| Client Name:                    | Evergreen EDC / Jireh Semiconductors  |  |  |
| Project Number:                 | M29-011A Date: June 8, 2012 - Rev1  |  |  |
| Building Name:                  | Evaluation of existing F1 occupancy electronic manufacturing Facility for compliance per current codes and for proposed future increase in use of TCS |  |  |

# Jireh Semiconductor T-Bay Code Review

Figure 2: T-Bay area occupancy

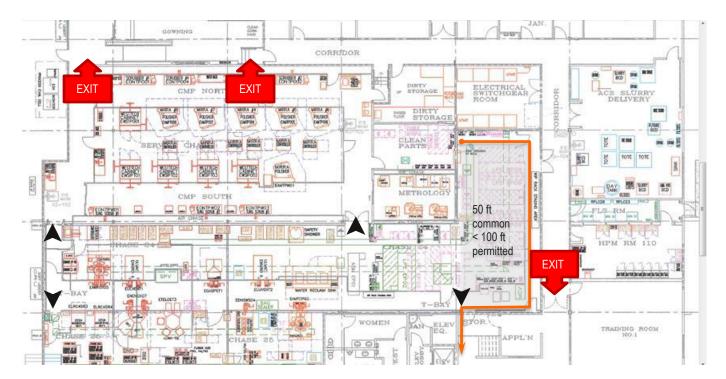
A T-Bay area is currently classified as a F1 Electronic Manufacturing area. This is still valid under the 2010 OSSC. There is no fire separation required between the F1 and adjacent B occupancy. The exit access corridor is separated by a 1 hour wall and 20 minute opening protection. It is recommended that the doors be upgraded to 45 minute rating to meet the control area separation under the current OSSC. This will help maintain the chemical quantities under the exempt amounts and also improve overall safety. Since this area is not an H occupancy area panic hardware is not required and doors do not have to swing in the direction of travel, but closers are required and any hardware will have to meet the new accessibility standards.

The equipment access double door has an 18 inch step down and does not serve as an exit. The owner wants to add an egress stair to use this as an exit access door. This is feasible and will need a new stair that meets 2010 OSSC and 2010 Accessibility Standards, which is possible without a significant cost impact. Existing means of egress system serving this area will meet current code requirements for travel distance (250 ft), common path (100 ft), and dead ends (50 ft).
